Maharashtra Metro Rail Corporation Limited
(A joint venture of Govt. of India & Govt. of Maharashtra)
Nagpur Metro Rail Project - Phase 2

Corrigendum-II

Tender No: N2-010/C-04/2023 dated 07-Sep-2023

Name of Work: Design and Construction of Elevated Metro Viaduct of length 5.333 km between Ch. (-)289.668 m to Ch. (-)5622.577 m in Reach 4A of NMRP Phase-2

MAHARASHTRA METRO RAIL CORPORATION LIMITED
 METRO BHAVAN, INFRONT OF DR. BABASAHEB AMBEDKAR COLLEGE, DEEKSHABHOOMI, NAGPUR- 4400010

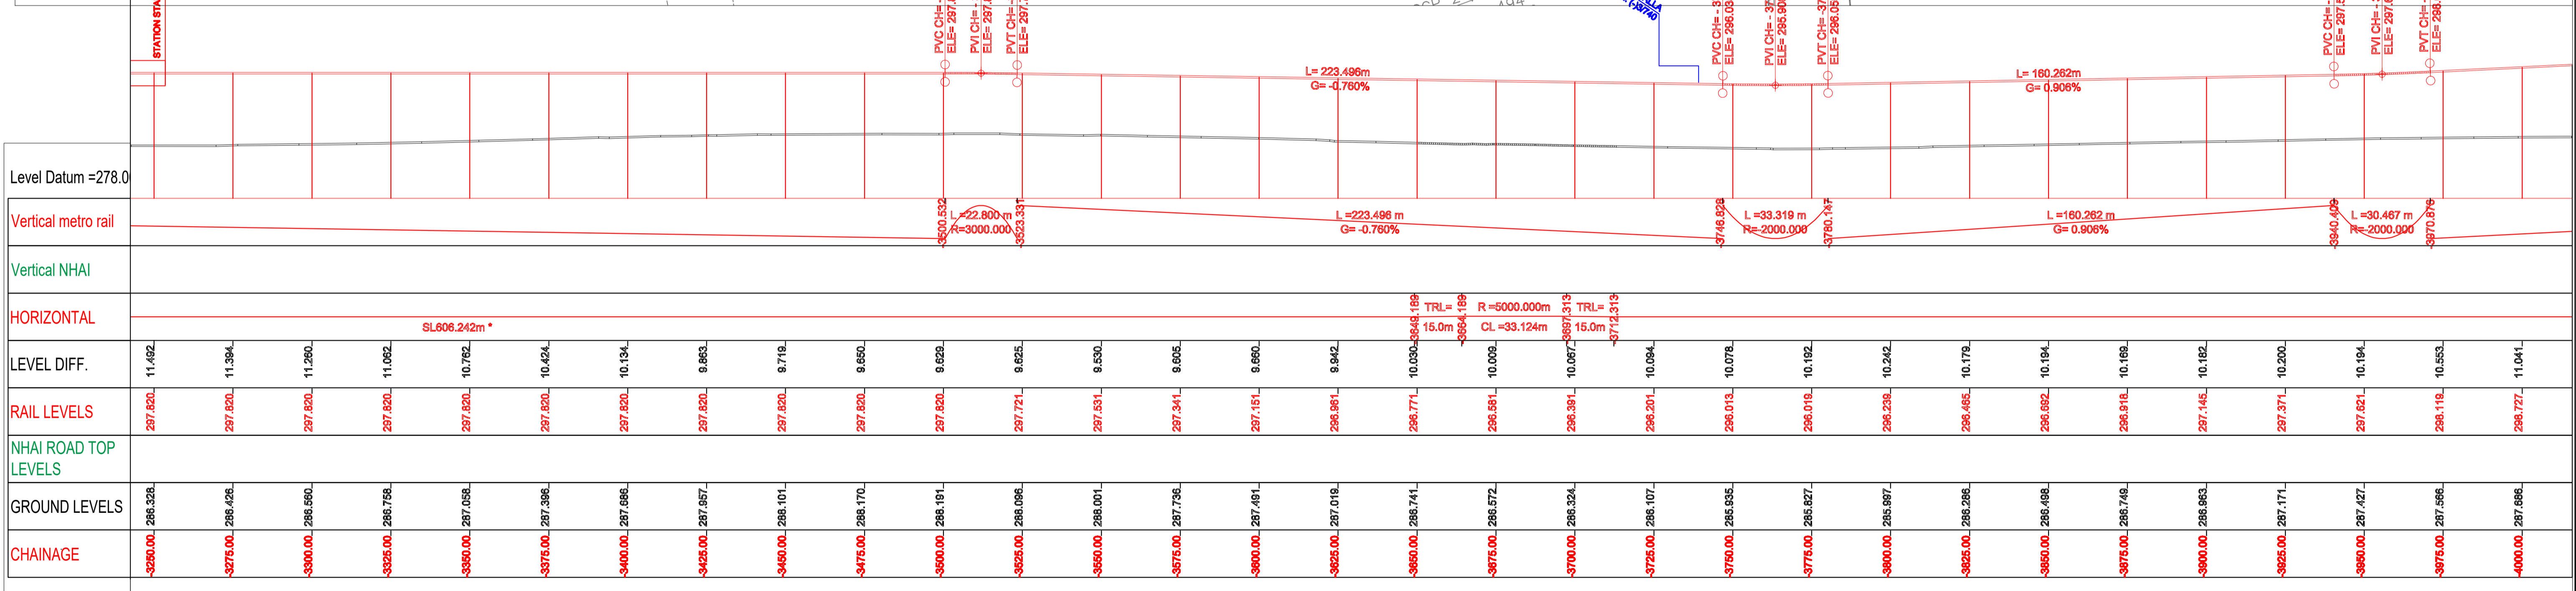
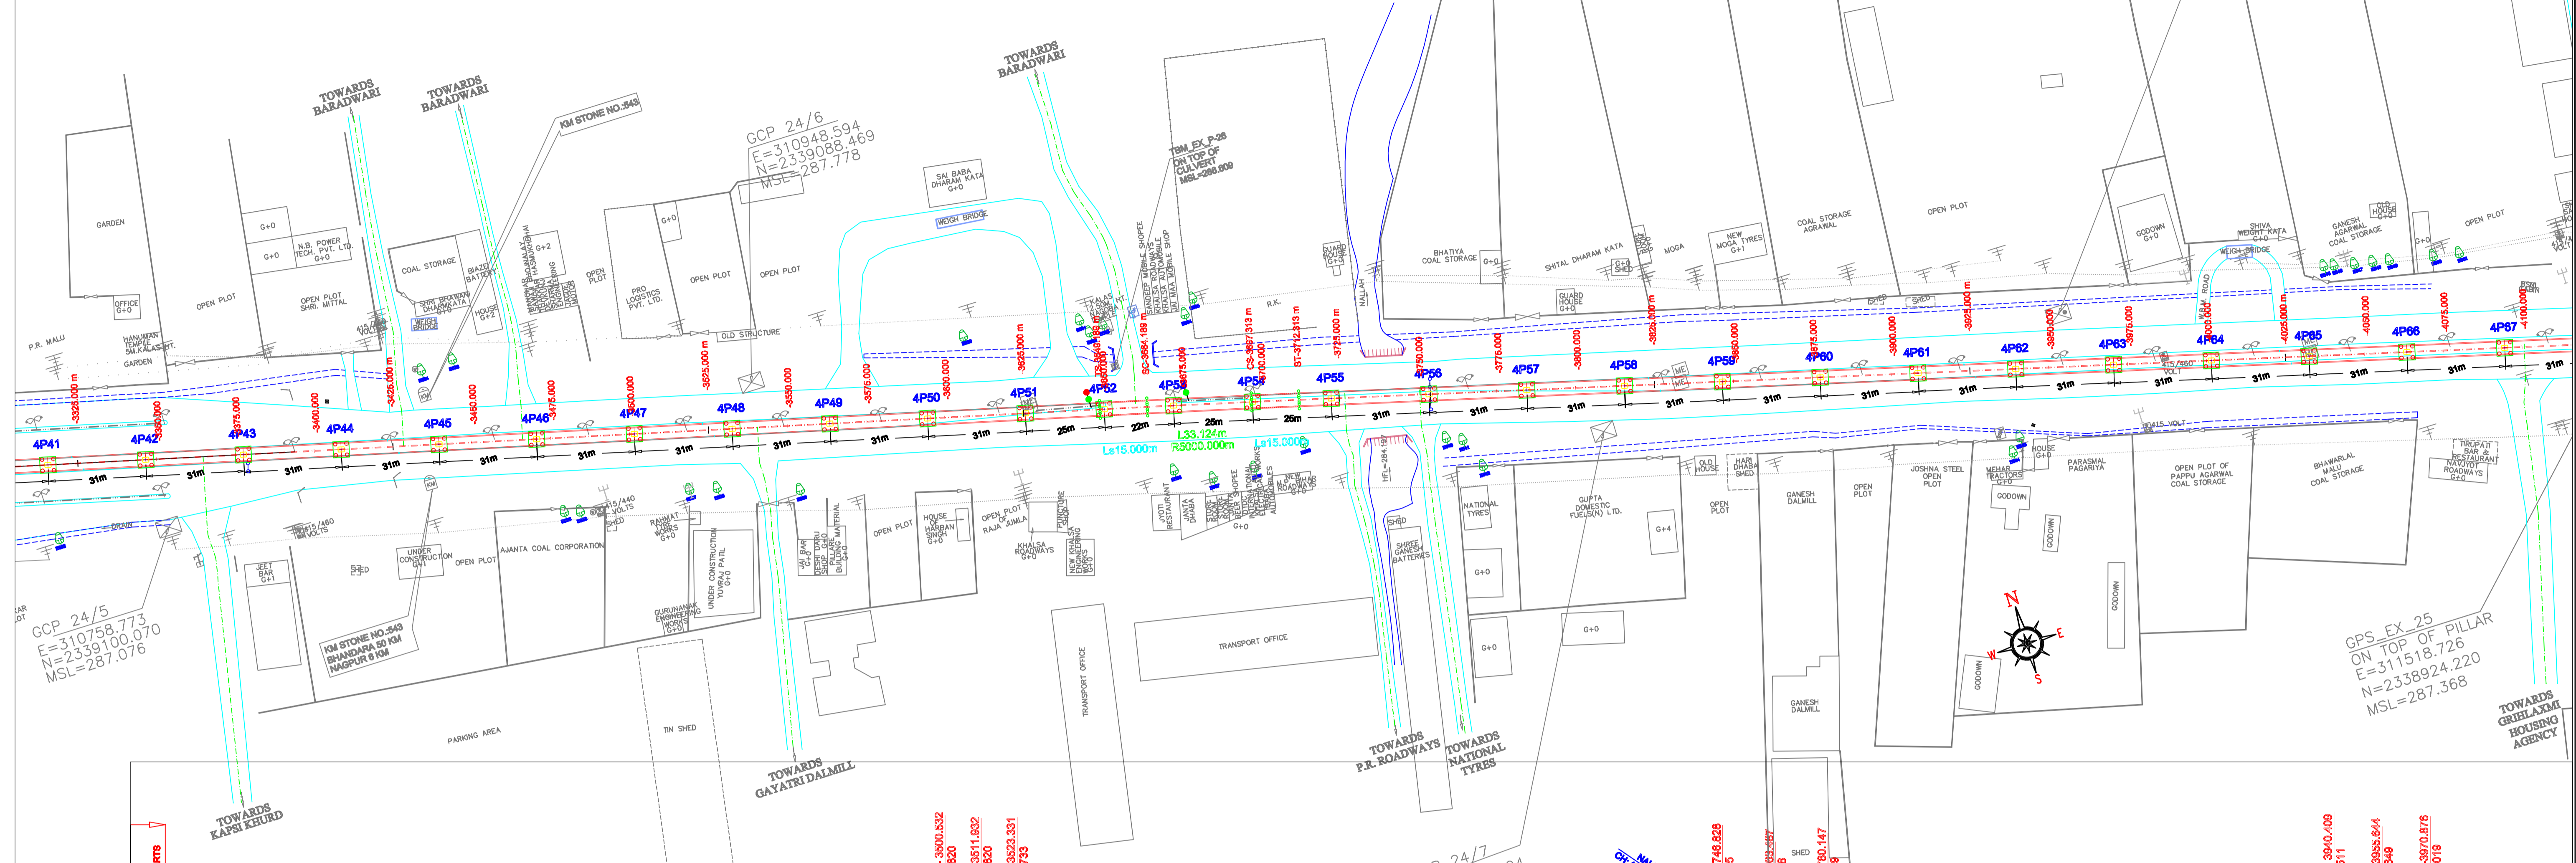
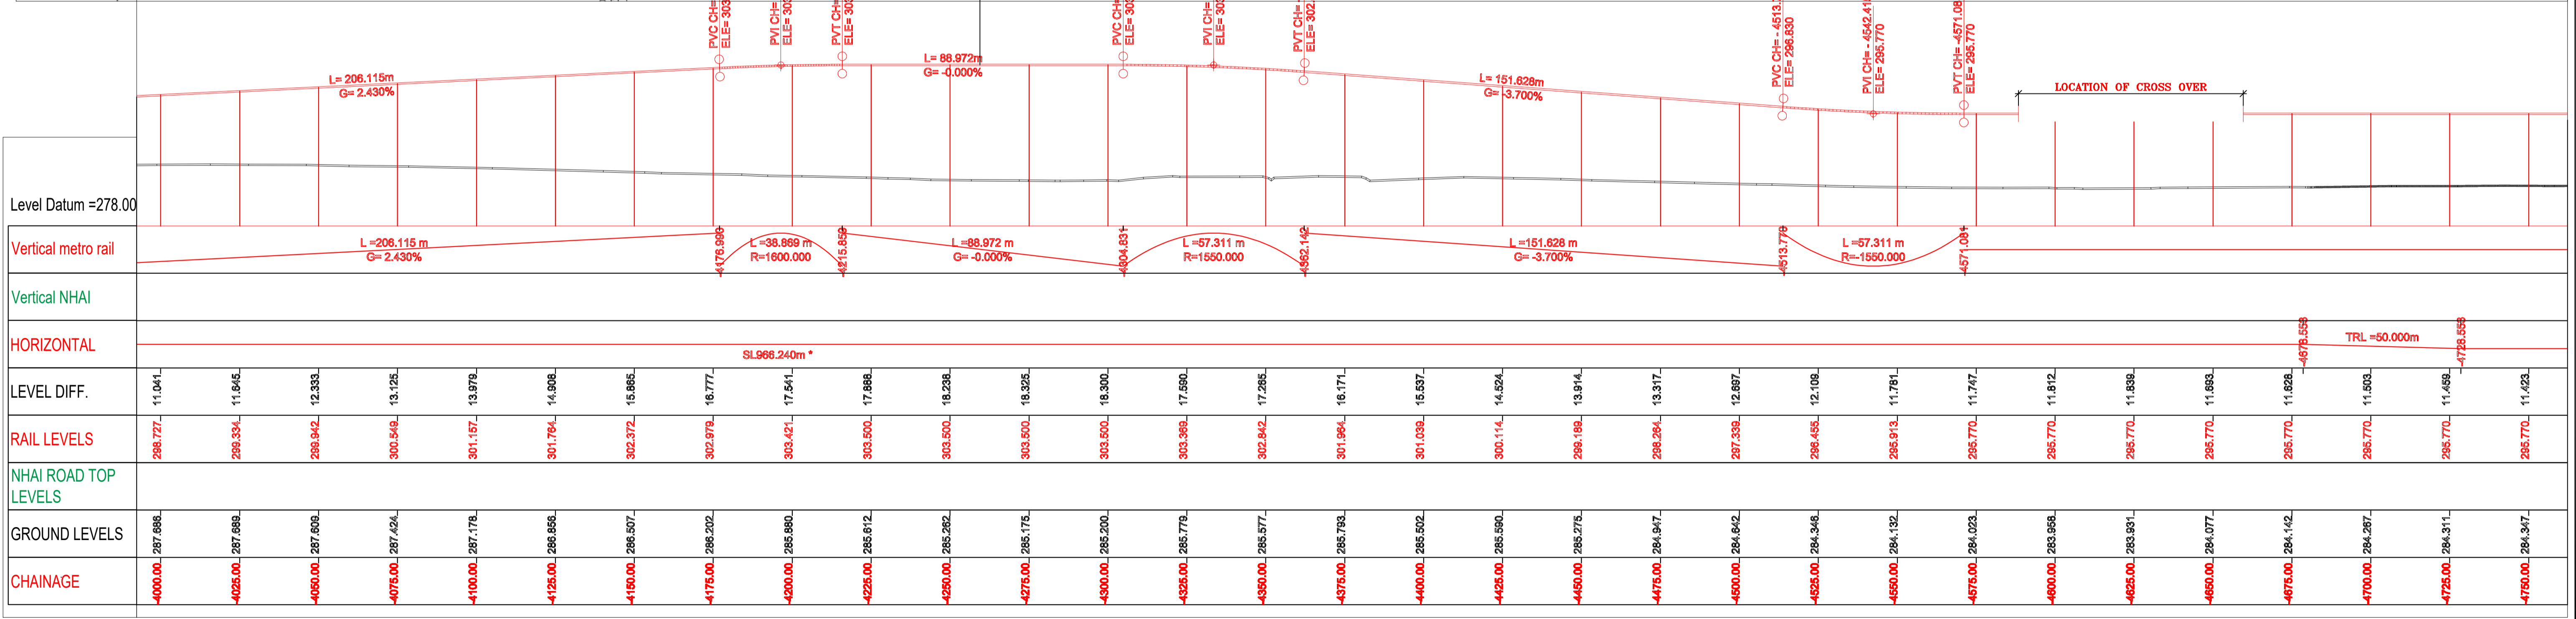
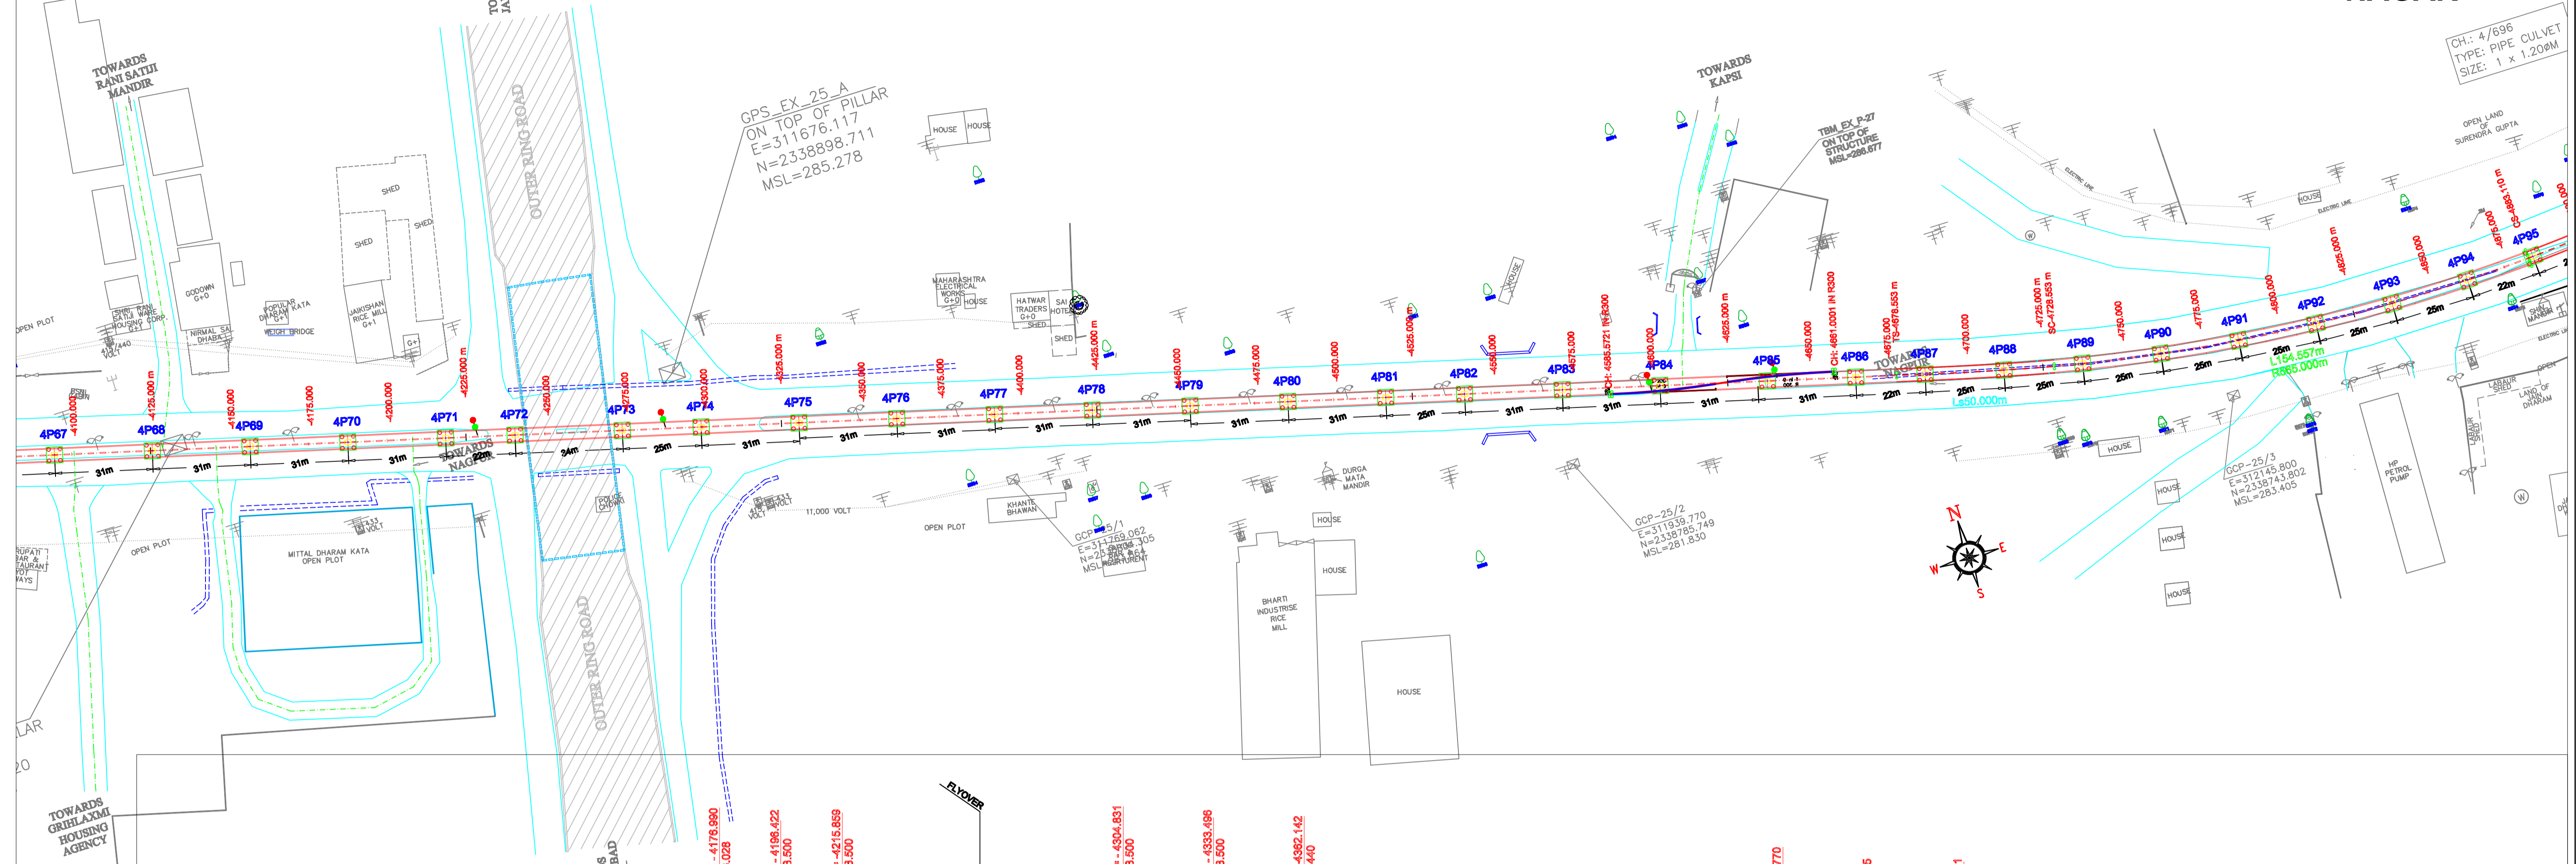
| Reference | Existing Provision | Revised Provision |
|--|---|---|
| Note no. 2 in GAD | Vertical profile as indicated in this tender drawing is based on GL/Road Level as surveyed during preparation of DPR in 2018. However, Contractor will have to ascertain its final value and maintain the requisite vertical clearance of 5.5m from existing/finished Road top level (as on date) to soffit level of Metro Superstructure. | Vertical profile as indicated in the tender drawing is based on GL/Road Level as surveyed during preparation of DPR in 2018. Maha-Metro Doesn't own any responsibility for the accuracy of the same, Contractor will have to ascertain its final value and maintain the requisite minimum vertical clearance of 5.5m from as built flyover Road top level (as on date of construction) in consonance with provision of IRC: 86-2018 from CH: (-)289.668 to (-)2250.000. Also, From CH: (-)2250 to CH: (-) 5560.827 shall maintain minimum vertical clearance of 5.8m from the existing road level. |
| GAD DWG NO. MM/PIg/NIT/NGP PH-II/4A/R1/2023 | GAD - DWG NO. MM/PIg/NIT/NGP/PH-II/4A/R1/2023 (Sheet 1 to 8) dated 12-July-23 | Revised Drawings are attached with this corrigendum: GAD - DWG NO. MM/PIg/NIT/NGP/PH-II/4A/R2/2023 (Sheet 1 to 8) dated 26-Oct-23 |
